IEC
60601-2-10

AMENDMENT 1
2001-09

Amendment 1

Part 2-10: Particular requirements for the safety of nerve and muscle stimulators

Figure 101 – Layout of testing arrangements (see 36.201.1.7 and 36.202.2.2d)

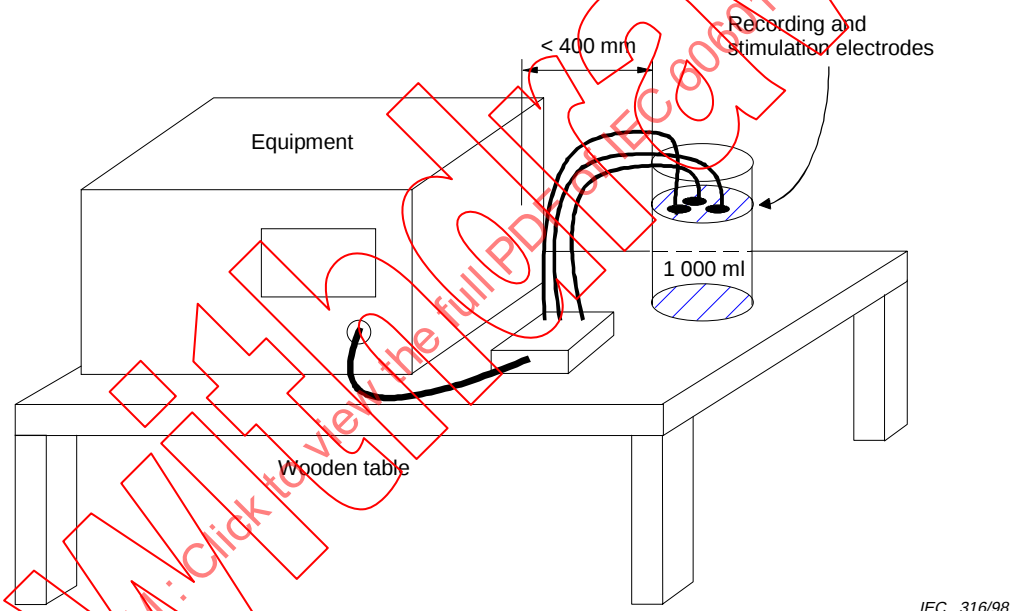
For the radiated radio-frequency emissions test, all relevant electrodes shall be connected and applied to the contents of a 1 000 ml capacity normal saline-filled phantom, positioned within 400 mm of the EQUIPMENT (see figure 101).

For the radiated radio-frequency electromagnetic field test, all relevant electrodes shall be connected and applied to the contents of a 1 000 ml capacity normal saline-filled phantom, positioned within 400 mm of the EQUIPMENT (see figure 101).

Replace the existing Figure 101 with the new Figure 101:
